DEVELOPMENT APPLICATION ASSESSMENT REPORT

Application Number:	DA2022/1971
----------------------------	-------------

Responsible Officer:	Michael French
Land to be developed (Address):	Lot 7 DP 209826, 13 Coniston Street WHEELER HEIGHTS NSW 2097
Proposed Development:	Alterations and additions to a dwelling house
Zoning:	Warringah LEP2011 - Land zoned R2 Low Density Residential
Development Permissible:	Yes
Existing Use Rights:	No
Consent Authority:	Northern Beaches Council
Land and Environment Court Action:	No
Owner:	Natalie Grove
Applicant:	Tekton Building Group

Figure 1: South side boundary envelope breach (highlighted red area depicting the area of building envelope non-compliance).

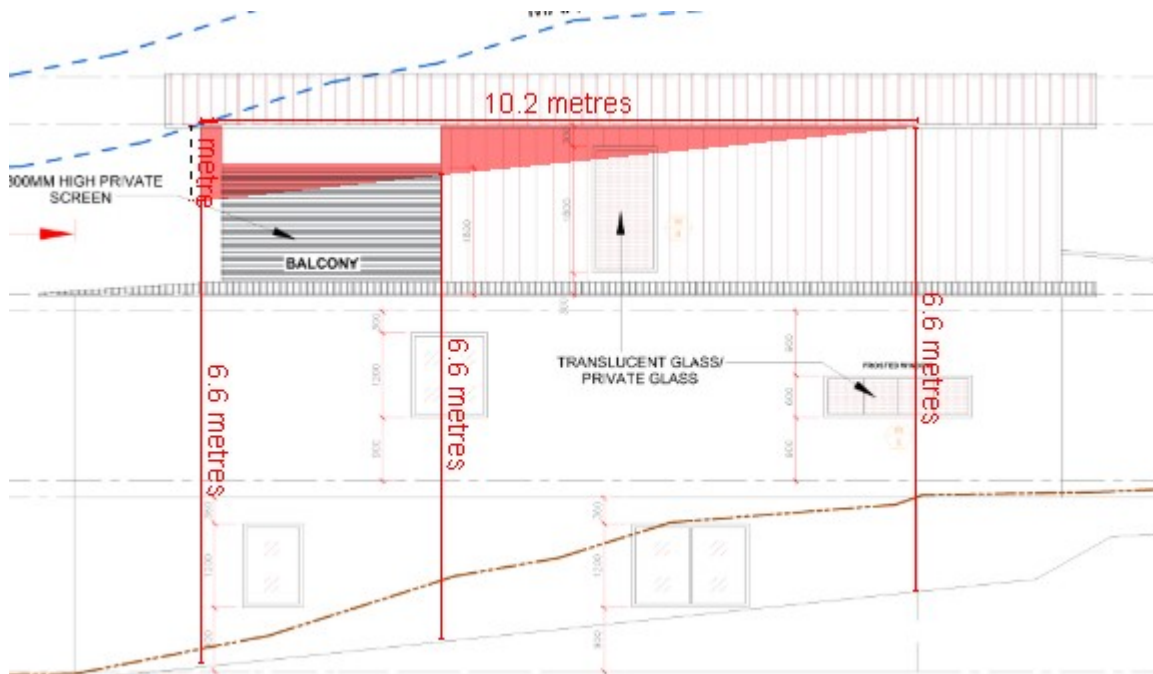
Clause B3 Side Boundary Envelope requires that built structures are sited within an envelope, measured at the side elevations of the dwelling by projecting planes at 45 degrees from a 4 metre height.

The proposed first floor addition and adjoining balcony will form an encroachment on the south elevation at a maximum height of 1m for a maximum length of 10.2m, causing a 25% variation.

In this regard, an assessment against the objectives of the control have been undertaken as detailed below.

The development as amended will not result in a structure that is excessive in terms of height or bulk. Additionally the proposal complies with *Clause B1 Wall Heights* and *Clause B5 Side Boundary Setbacks*.

The development as amended is considered to provide adequate light, solar access and privacy by providing spatial separation between buildings. Further assessment on access to sunlight is detailed elsewhere within this report.

The proposal is considered to respond adequately to the topography of the site. Strict compliance with *Clause B3 Side Boundary Envelope* is not necessary in this instance due to the steep downward slope toward the south-west corner of the site. It should be noted that the the proposal as amended remains compliant with *Clause B1 Wall Heights* and *Clause B5 Side Boundary Setbacks*.
